Network Video Recorder

Version: V4.61.400 build220817

Release Note

Firmware Basic Information	Firmware Version:	V4.61.400 build220817
	Web component:	V4.5.0build220715

【Support More Ultra HD Resolution Camera Access】

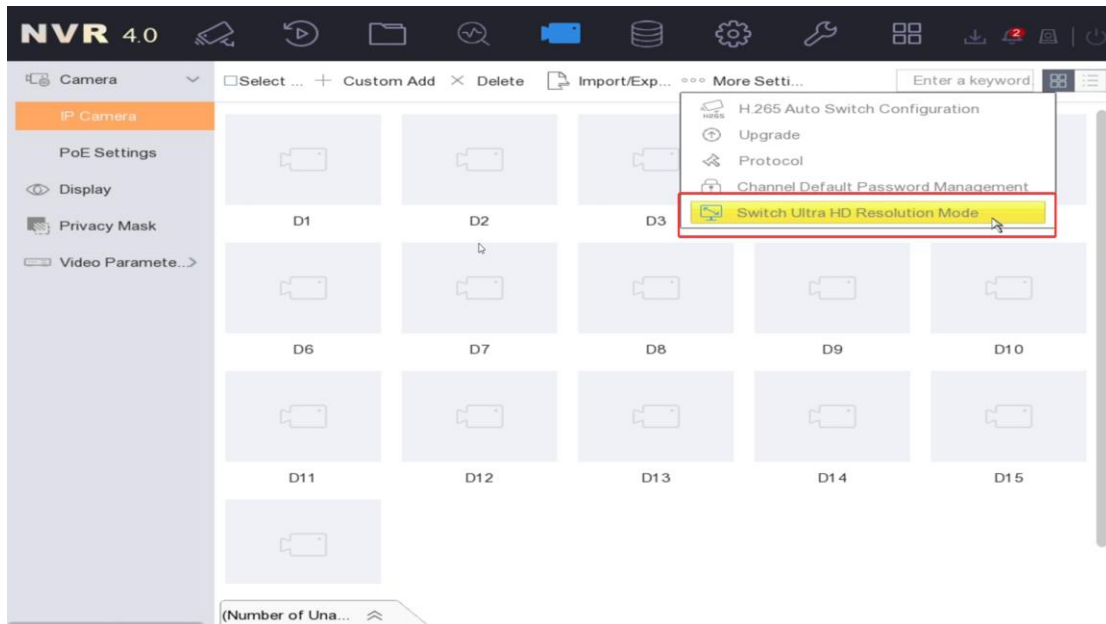
Under Ultra HD Resolution Mode, more ultra HD camera can be connected (from 4 channels to 8 channels).
